WYONG SHIRE COUNCIL

Prepared by:
Maunsell Australia Pty Ltd

Wyong Temporary Desalination Plant - Lakes Beach

This Planning Report has been prepared by Maunsell Australia Pty Ltd on behalf of Wyong Shire Council to independently assess the development application for the proposed **Lakes Beach Temporary Desalination Plant**. This assessment has been prepared in accordance with Part 4 of the *Environmental Planning and Assessment Act 1979* (EP&A Act).

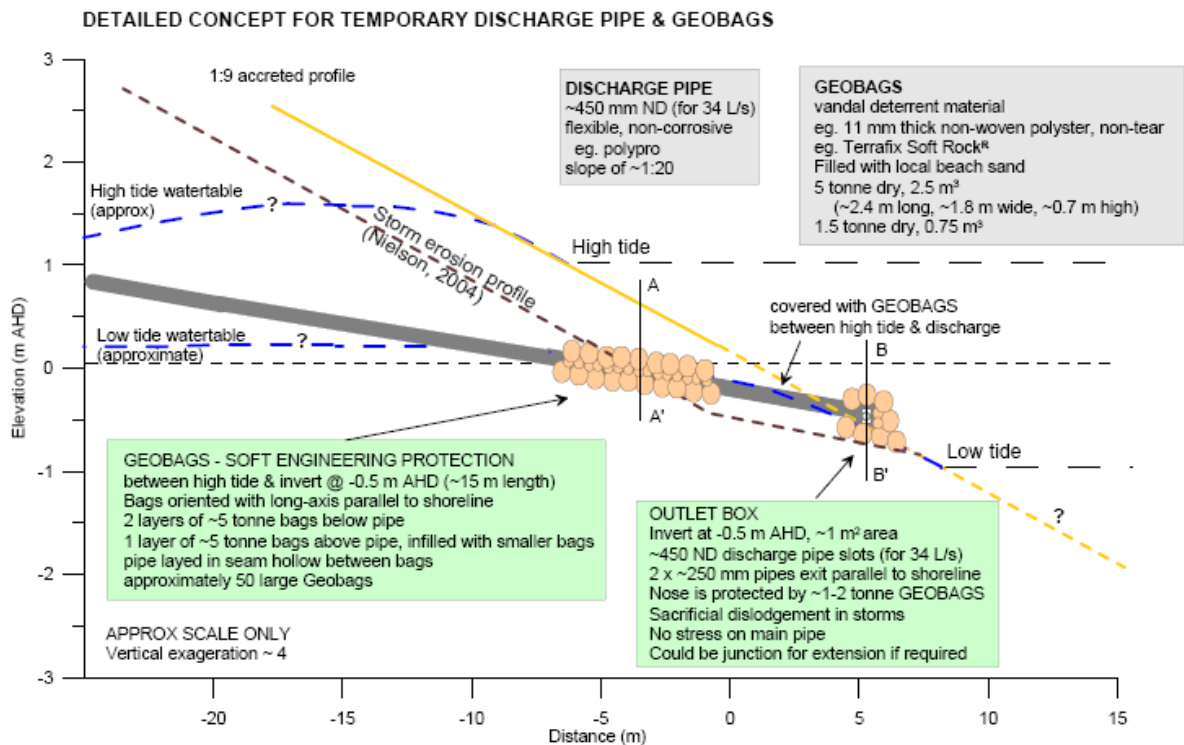
Establishing a seawater outfall above the beach profile will generate a negative impact on the visual landscape by interrupting what is now a continuous beach foreshore. However, due to the temporary nature of the proposal and the community benefit from augmenting water supplies, the detrimental impact generated by the proposed outfall infrastructure is considered reasonable. This assumes that the seawater discharge infrastructure is to be completely removed upon cessation of operations.

In extreme storm events, there is potential for the seawater outfall infrastructure to be further exposed. Reference is made to Figure 4.1 (reproduced below) of the design report (UNSW Water Research Laboratory, 2006), which demonstrates the extent to which the geobags may be exposed if a severe storm causes significant erosion.

PROFILE AFTER 100 YEAR ARISTORM

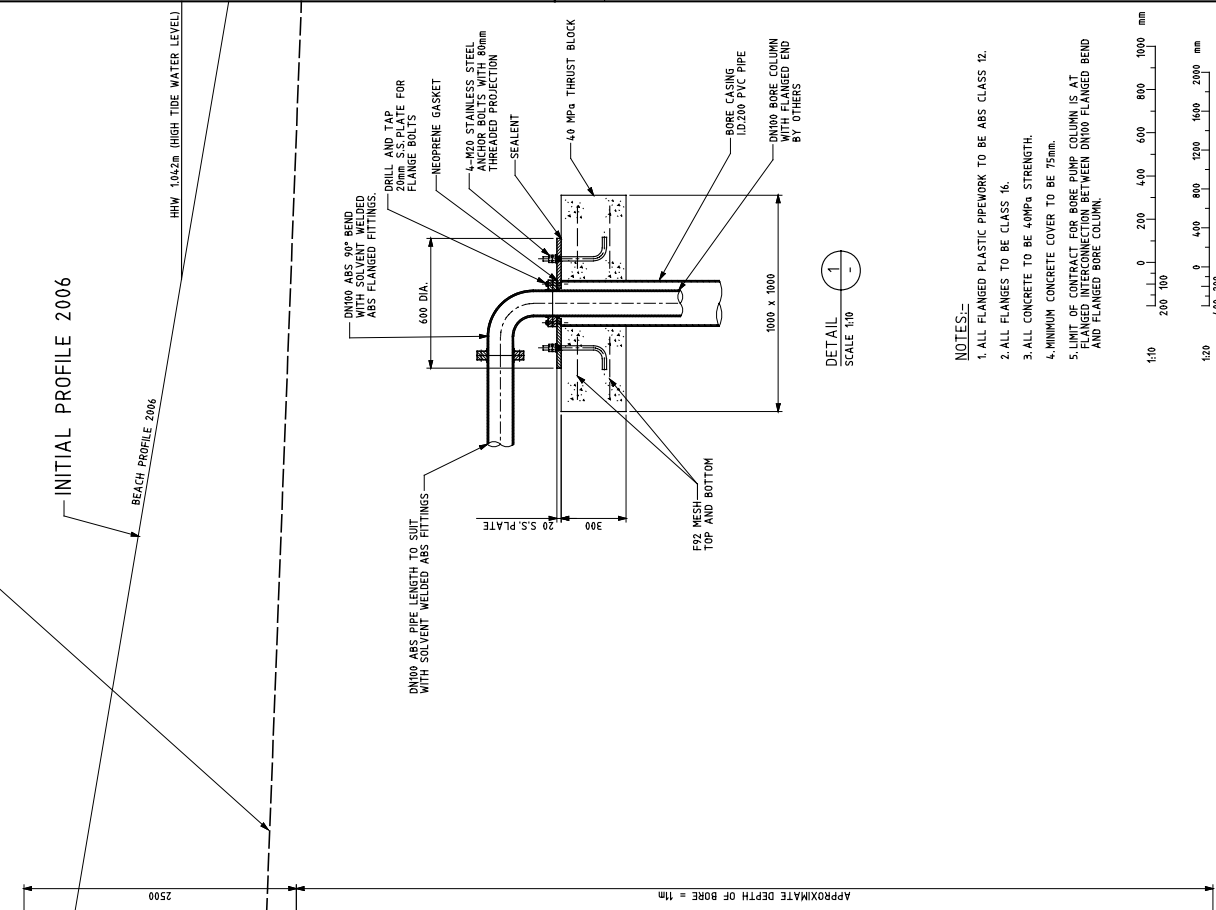
Due to the potential for large seas to remove sand from the beach, the depth of the beach well infrastructure was amended post-lodgement of the development application, to locate the infrastructure immediately below the 1 in 100 year ARI event beach profile. However, the background information used to derive storm erosion profiles is scarce and the methods used to calculate storm profiles are indicative at best.

Manly Hydraulics Laboratory, in their report accompanying the development application (Appendix B to the SEE), recommends burying infrastructure 1m below the 1 in 100 year ARI event beach profile to provide a factor of safety. On the basis of the MHL advice, the infrastructure should be relocated to this level.

TYPICAL CONDUIT / PIPE BEDDING DETAILS FOR 4 ML/DAY PROPOSALS
SCALE 1:10

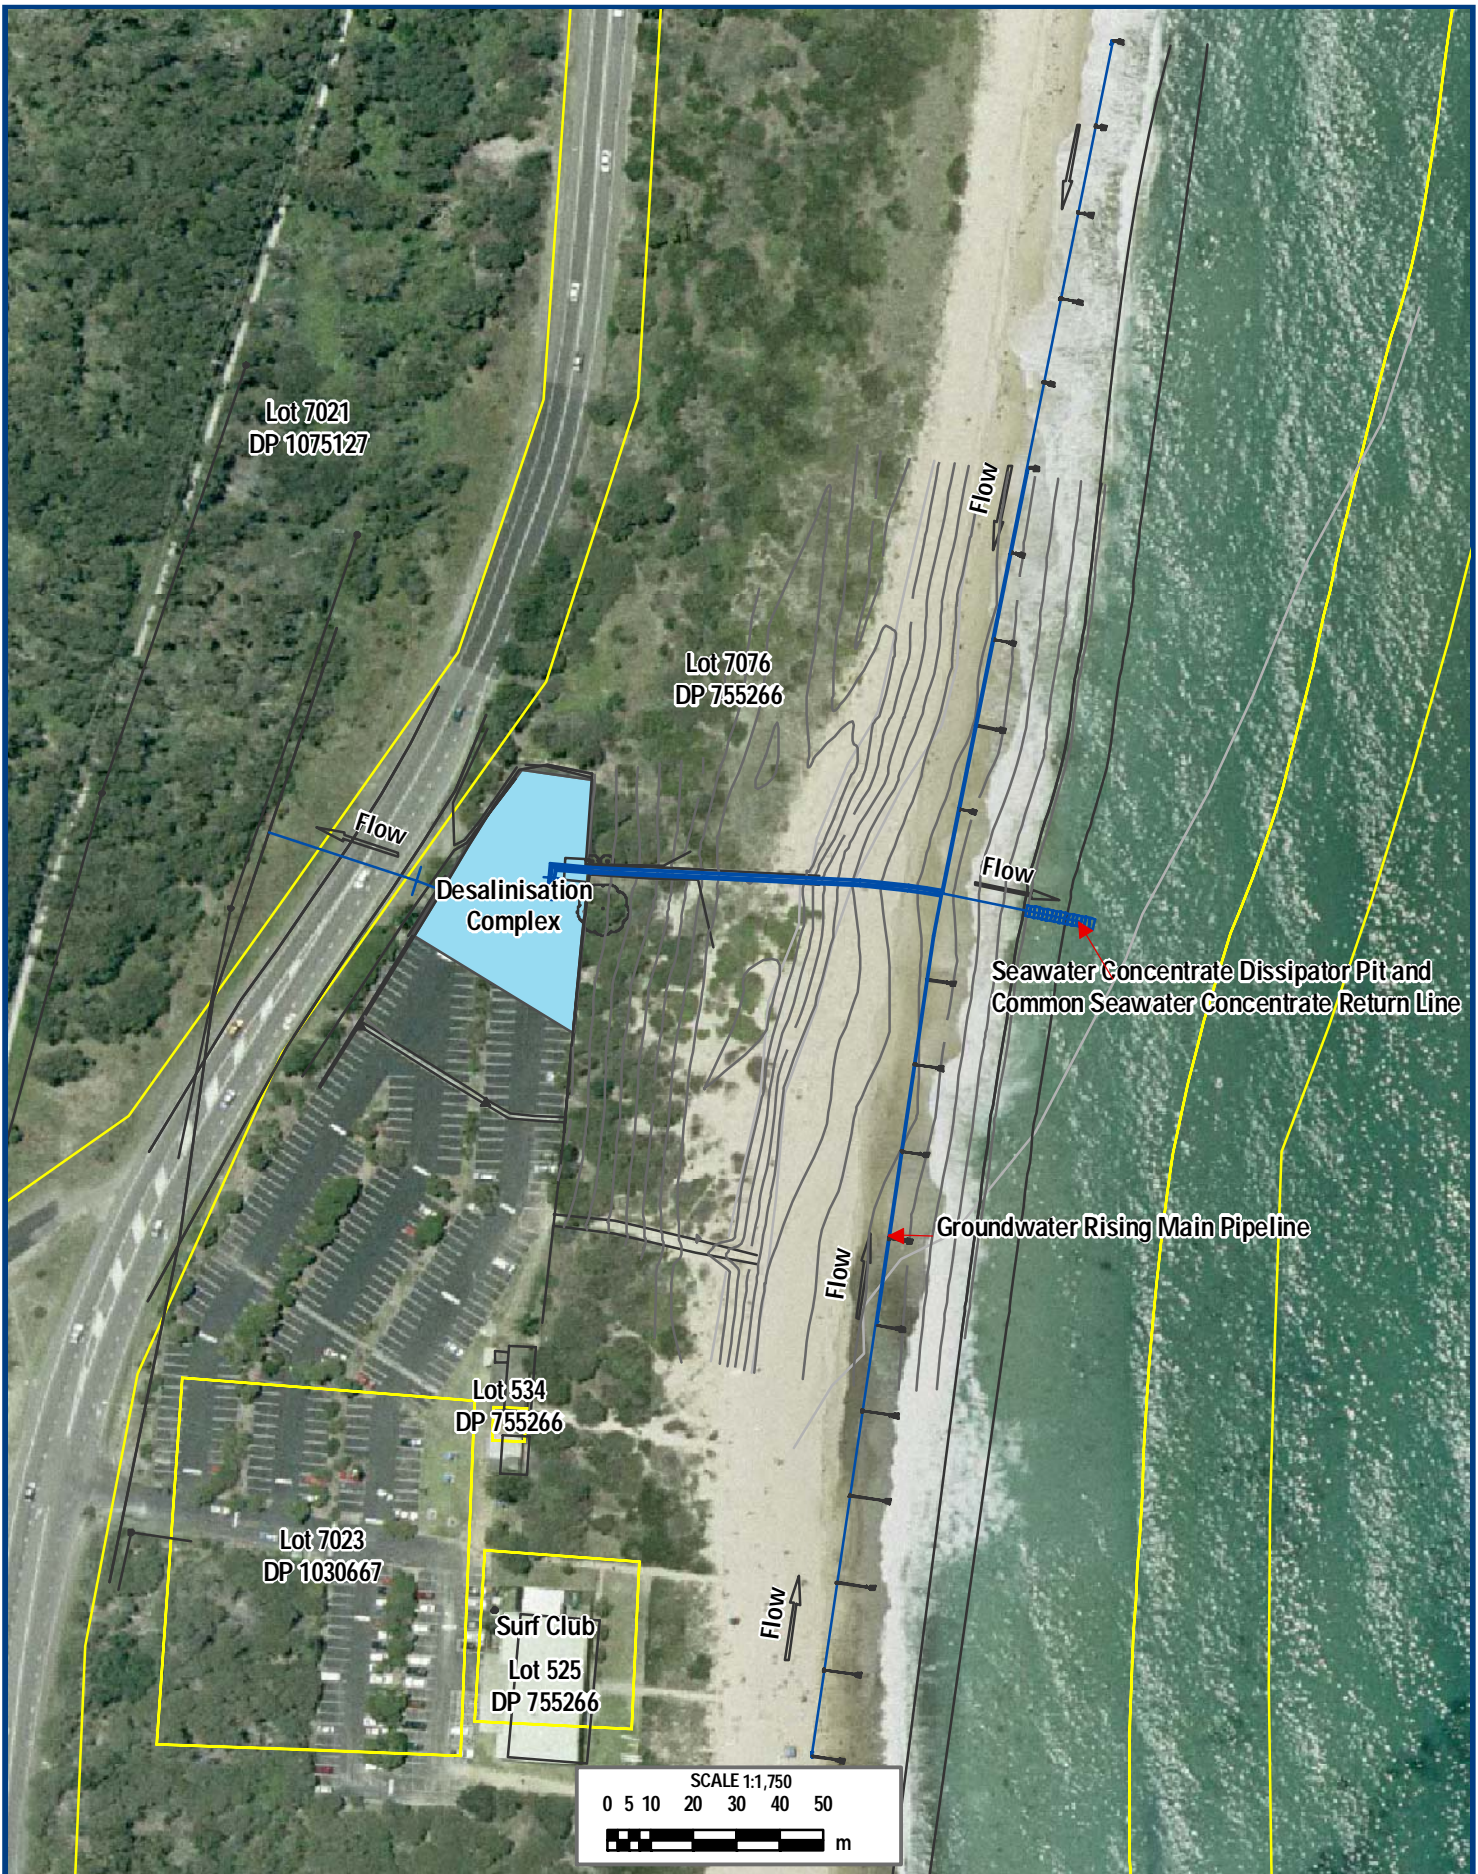
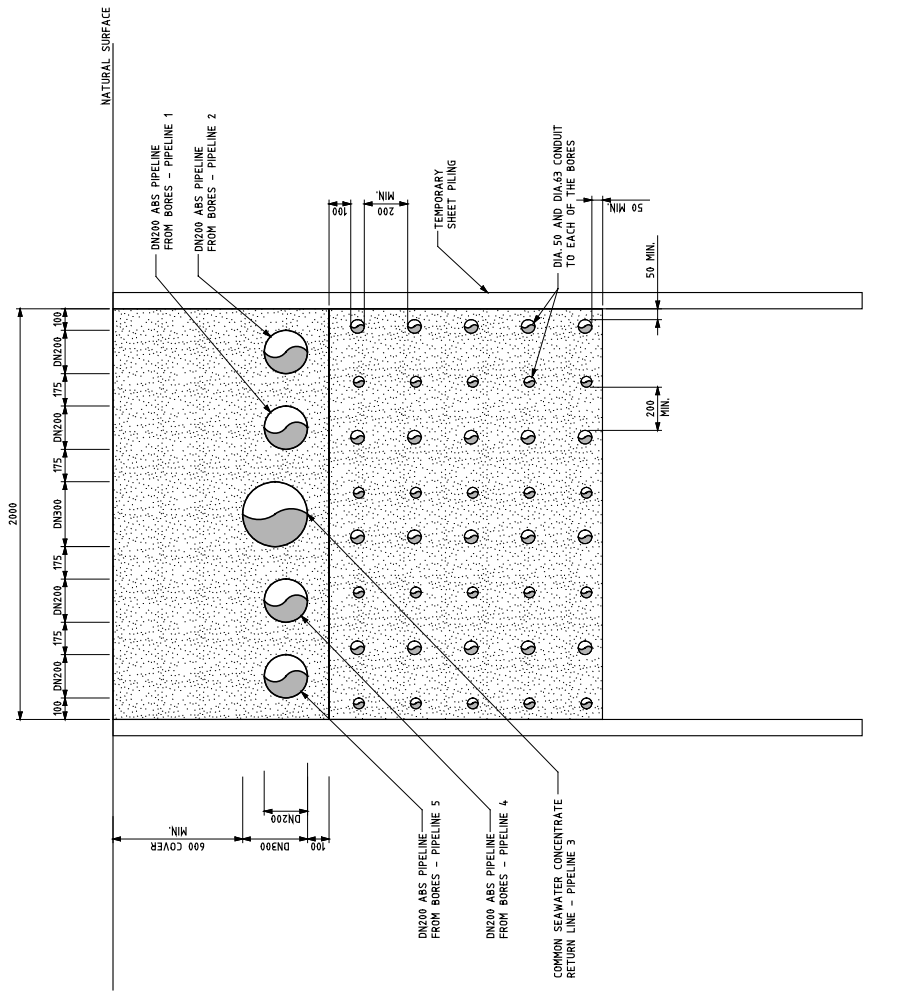
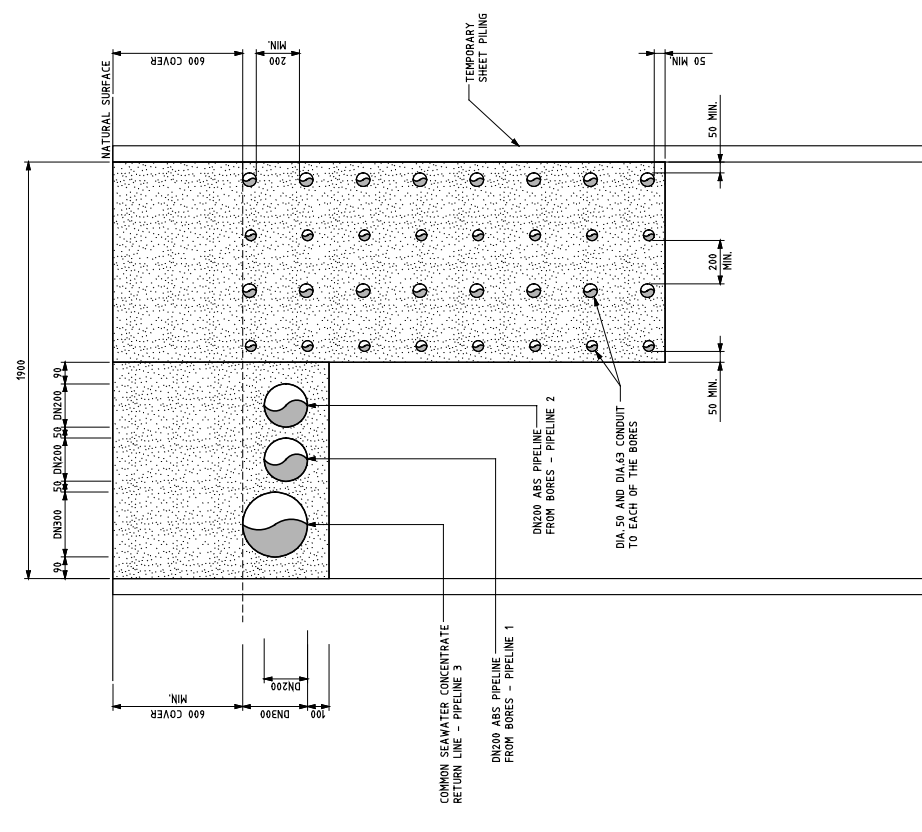
Further information was received from the applicant (Drawing Reference: WYONG 603, dated 13/12/2006) that demonstrates the conduits and pipes across the sand dune will be constructed using temporary sheet piling (or using trench boxes). This construction method avoids the need for a wide excavation trench and subsequently minimises vegetation clearance.
